Scale 1:200 @ A3
TCL
03.08.2020

BONACCI MARKUP
04.08.2020

SOUTHERN COURTYARD

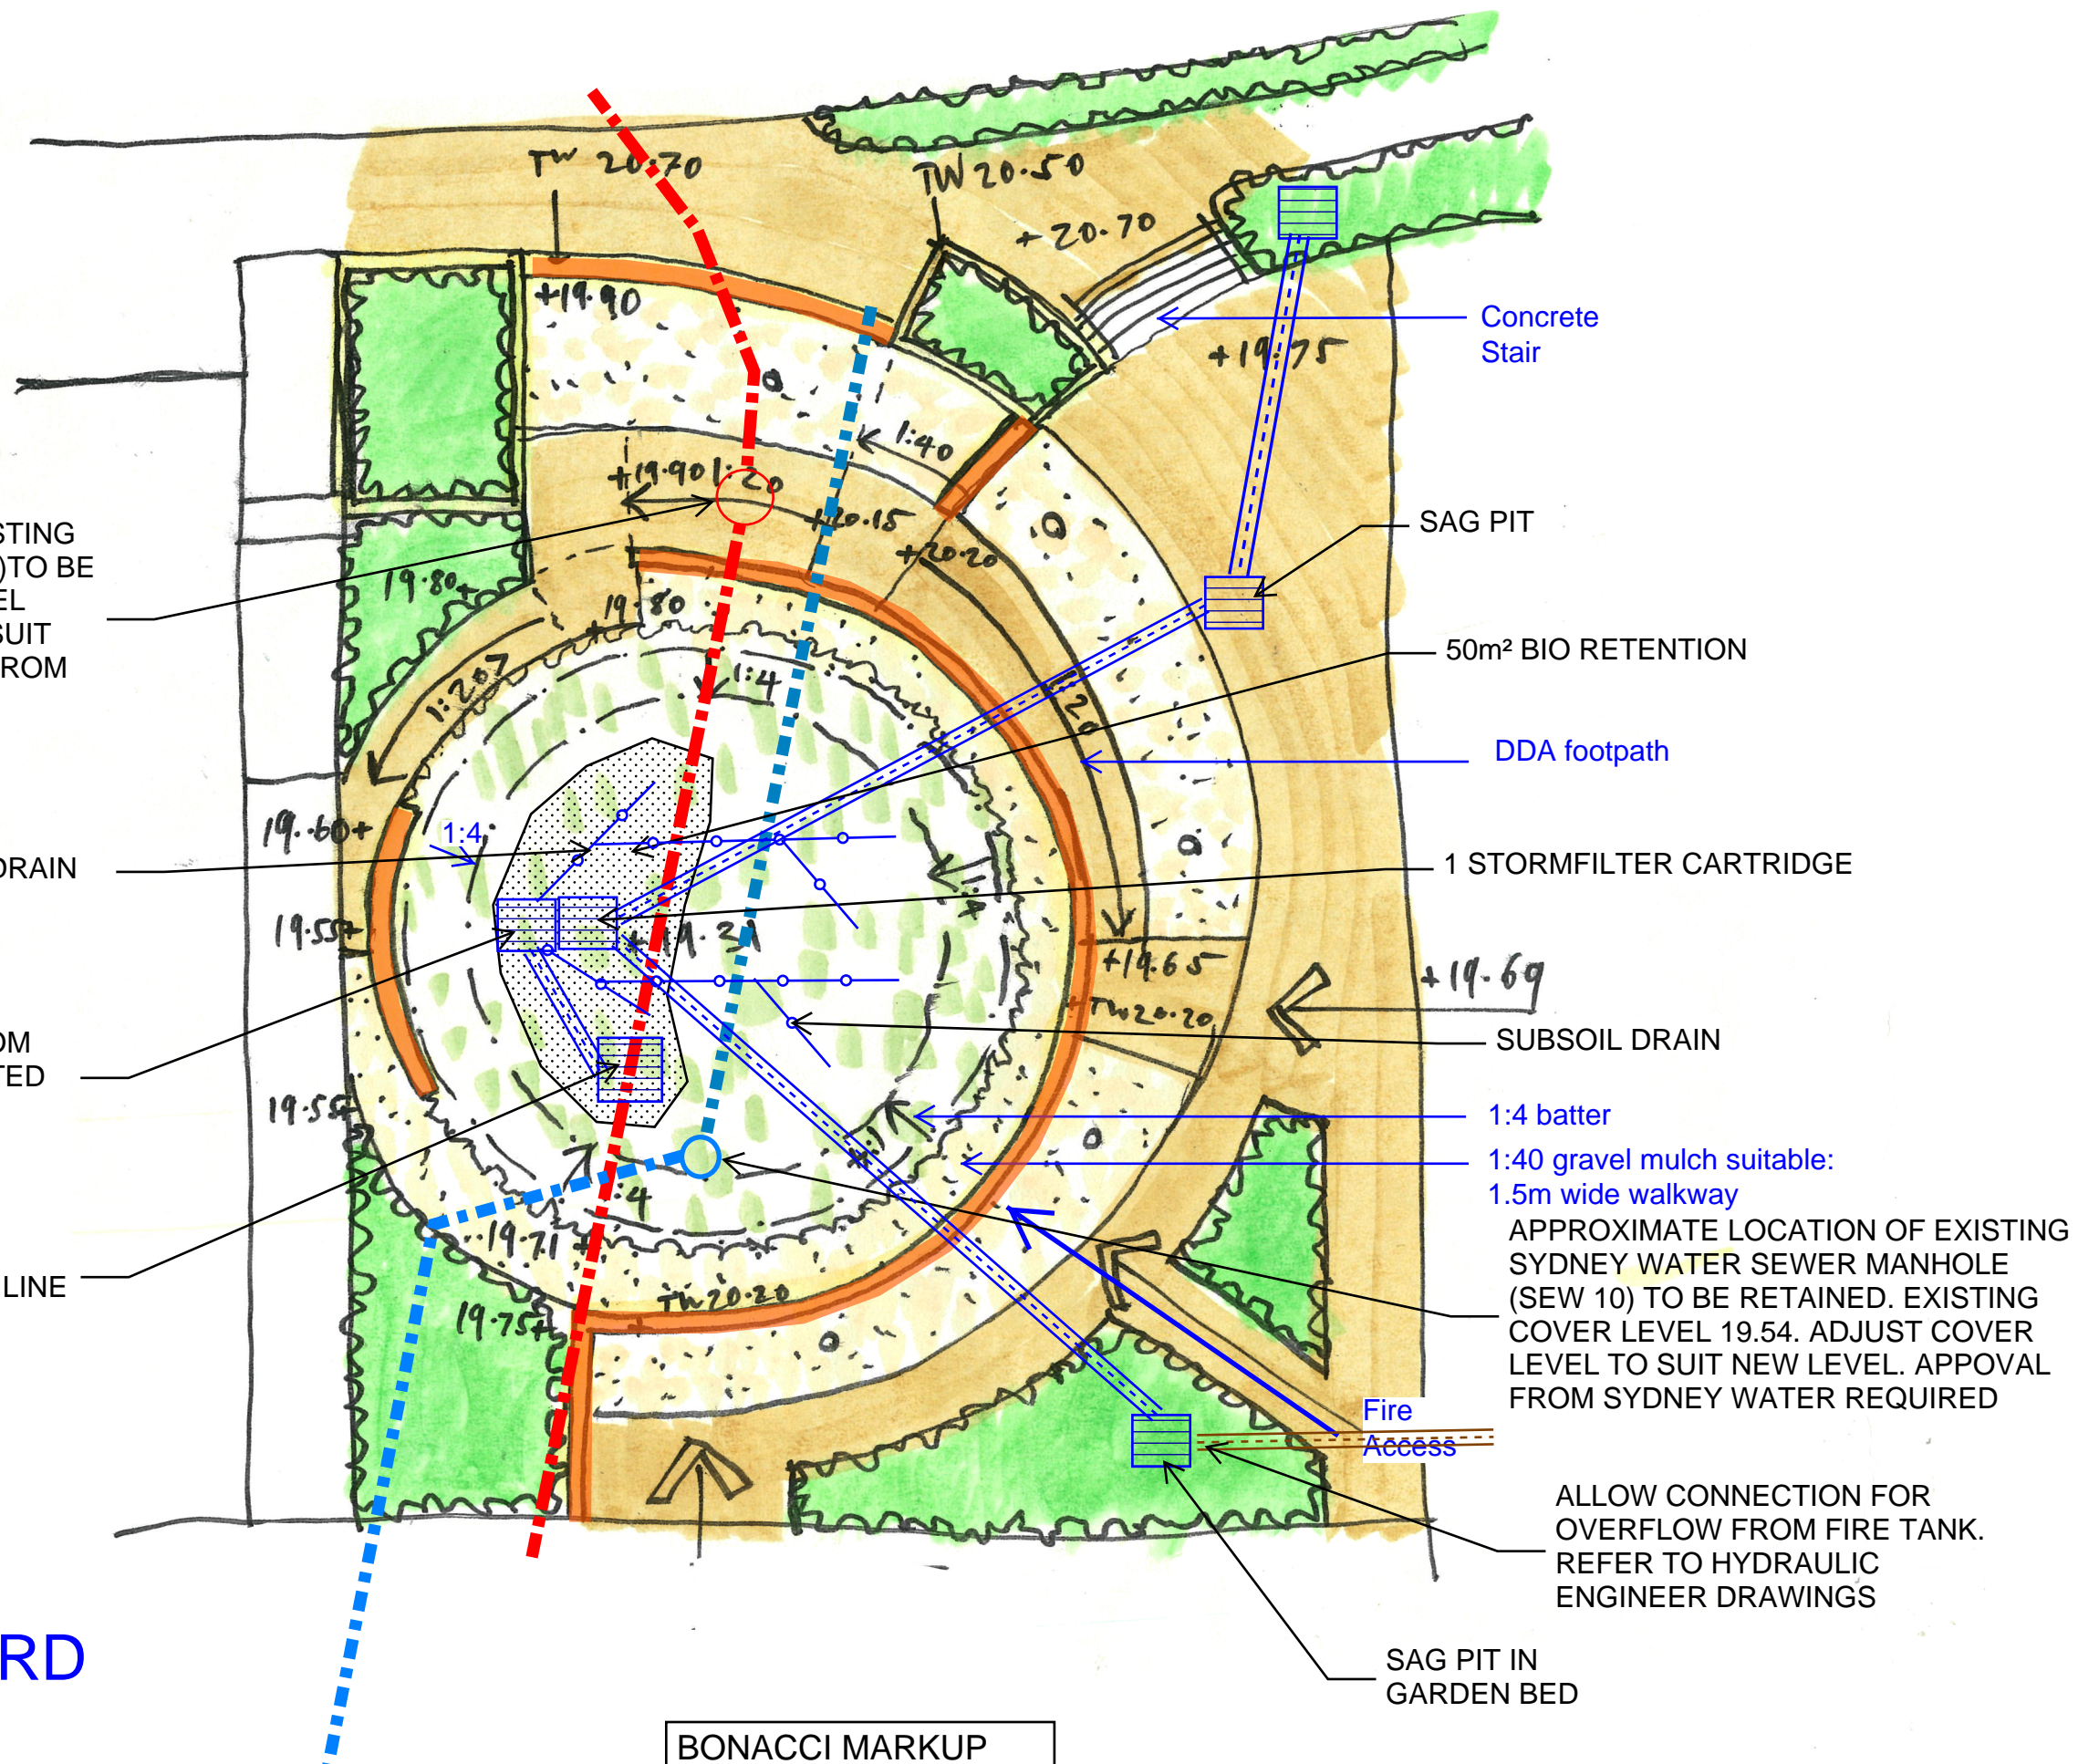
APPROXIMATE LOCATION OF EXISTING SYDNEY WATER MANHOLE (SW36) TO BE RETAINED. EXISTING COVER LEVEL 19.52. ADJUST COVER LEVEL TO SUIT NEW PAVING LEVEL. APPROVAL FROM SYDNEY WATER REQUIRED

OVERFLOW PIT FROM BIORETENTION FITTED WITH ENVIROPOD

CONNECTION TO THE EXISTING SYDNEY WATER STORMWATER LINE

SECTION A-A (NTS)

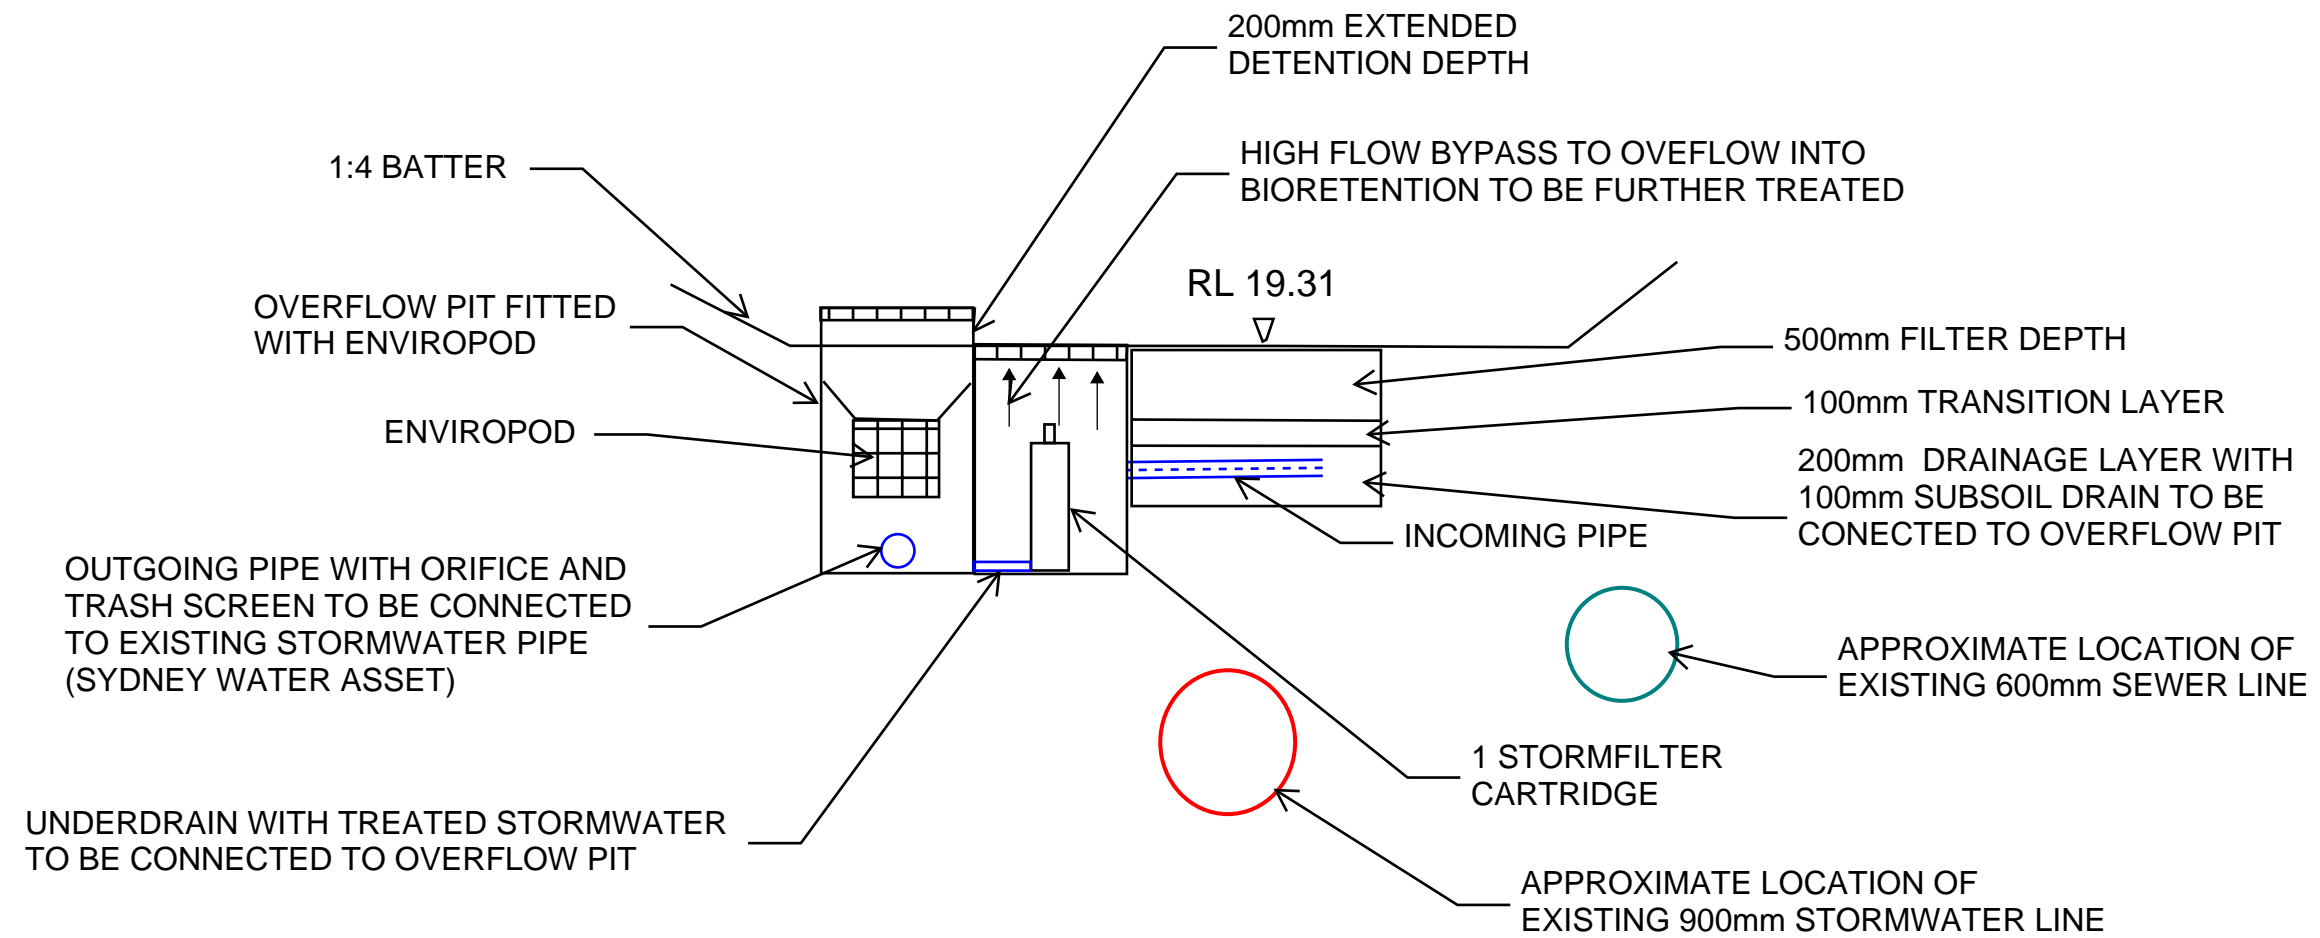
BIO RETENTION BASIN (50m²) WITH OVERFLOW PIT AND STORMFILTER CARTRIDGE CHAMBER
